Economic Commission for Europe**Inland Transport Committee****World Forum for Harmonization of Vehicle Regulations****Working Party on General Safety Provisions****112th session**

Regulation No. 43 (Safety glazing)**Proposal for Supplement 6 to the 01 series of amendments to Regulation No. 43 (Safety glazing)****Submitted by the expert from Germany***

I. Proposal

Figure 4.1
Diagram of abrading instrument

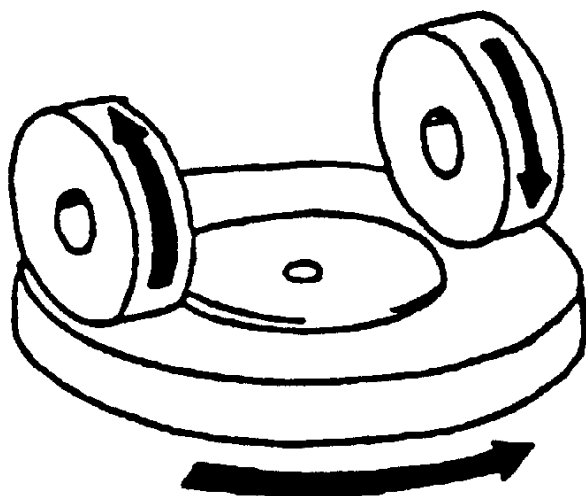
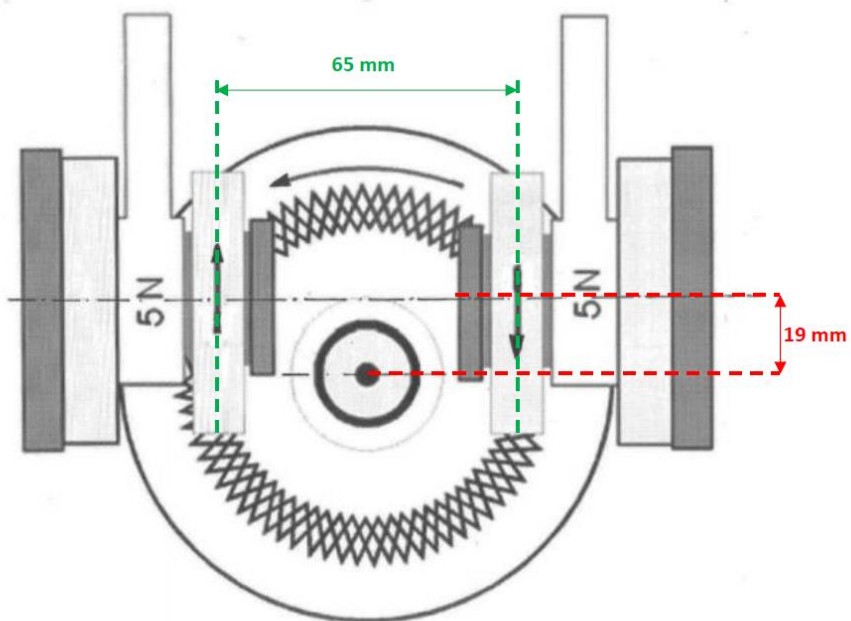
Paragraphs 4.1.1. to 4.1.2., amend to read (also renumbering Figure 4 to 4.1 and inserting new Figure 4.2):

"4.1.1. Abrading instrument¹, shown diagrammatically in ~~Figure 4~~ **Figures 4.1 and 4.2** and consisting of:

(a) A horizontal turntable, with centre clamp, which revolves counter-clockwise at ~~65 to 75~~ **a fixed speed of 60 ± 2 rev/min or 72 ± 2 rev/min**;

(b) Two weighted parallel arms each carrying a special abrasive wheel freely rotating on a ball-bearing horizontal spindle; each wheel rests on the test specimen under the pressure exerted by a mass of 500 g. **The distance between the internal faces of the wheels shall be $52.4 \text{ mm} \pm 1.0 \text{ mm}$ (which corresponds to a distance between the symmetry planes of the wheels of 65.1 mm). The horizontal offset of a virtual line, which runs through both wheel axes, from the turntable axis shall be $19.05 \text{ mm} \pm 0.30 \text{ mm}$.**

(c) **A vacuum suction system (not depicted in Figures 4.1 and 4.2) and vacuum pick-up nozzle to remove debris and abrasive particles from the test piece surface during testing. The height of the vacuum pick-up nozzle shall be adjustable, and the nozzle openings shall have a diameter of 11 mm.**

The wheels shall be ~~mounted in such a way that when~~ **placed evenly on the test piece in their full width. When** they are in contact with the rotating test piece they rotate in opposite directions so as to exert, twice during each rotation of the test piece, a compressive and abrasive action along curved lines over an annular area of about 30 cm^2 .

Figure 5.1
Hazemeter

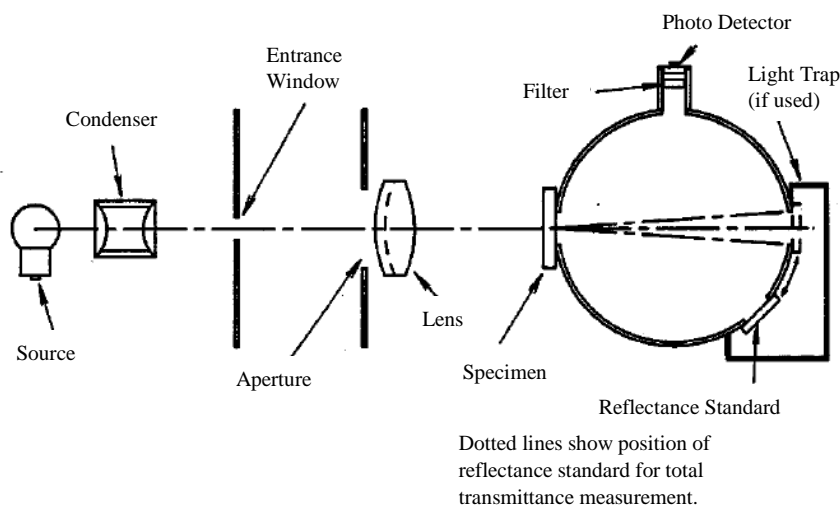
Paragraphs 4.1.4. and 4.1.5., amend to read (also replacing Figure 5.1):

"4.1.4. Optical system consisting of a lens with a focal length f of at least 500 mm and corrected for chromatic aberrations. The full aperture of the lens shall not exceed $f/20$. The distance between the lens and the light source shall be adjusted in order to obtain a light beam which is substantially parallel. A diaphragm shall be inserted to limit the diameter of the light beam to $7 \text{ mm} \pm 1 \text{ mm}$. This diaphragm shall be situated at a distance of $100 \text{ mm} \pm 50 \text{ mm}$ from the lens on the side remote from the light source. ~~Illuminate the test piece by a substantially unidirectional beam; the maximum angle that any ray of this beam may make with the beam axis shall not exceed 0.05 rad (3°). This beam shall not be vignette at either port of the sphere.~~

When the test piece is placed against the entrance port of the integrating sphere, the angle between the perpendicular to the test piece and a line connecting the centres of entrance and exit ports shall not exceed 0.14 rad (8°).

An aperture or diaphragm shall be centrally inserted in the haze measuring apparatus to centre the light beam on the abradant track and limit it to a diameter of $7 \text{ mm} \pm 1 \text{ mm}$ at the test piece.

When the reduced light is unobstructed by a test piece, its cross section at the exit port shall be approximately circular, sharply defined, uniformly bright, and concentric within the exit port, leaving an annulus of $0.023 \text{ rad} \pm 0.002 \text{ rad}$ ($1.3^\circ \pm 0.1^\circ$) subtended at the entrance port.

The surfaces of the interior of the integrating sphere, baffles, and reflectance standard, if used, shall be of equal reflectance, matte, and highly reflecting throughout the visible spectrum.

A light trap shall be provided that will absorb the beam completely when no test piece is present, or the instrument design shall obviate the need for a light trap.

Figure 5.2

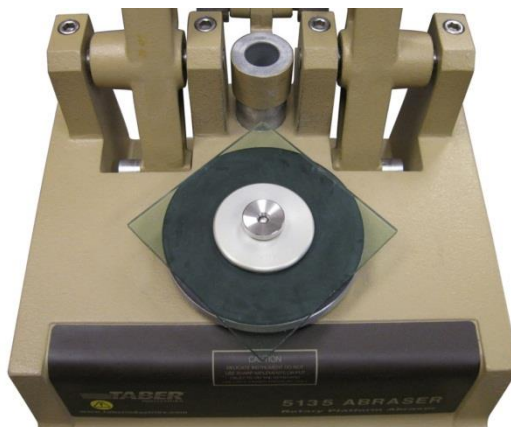
Insert new paragraphs 4.4.4. to 4.4.6., to read (inserting also new Figure 5.2):

Mount the test piece on the abraser turntable platform with the side to be abraded facing up. The test piece shall be mounted at a 45° angle from the front of the machine as shown in Figure 5.2. Secure using the clamp plate and nut. Affix the load corresponding to a total load of 500 g (per wheel) to the abraser. Lower the vacuum pick-up nozzle and adjust the height to 1 mm above the test piece surface with a gage having a thickness equal to 1 mm or a gage pin having a diameter equal to 1 mm. After setting the height of the vacuum nozzle, ensure the rear vacuum nozzle does not contact the test piece surface.
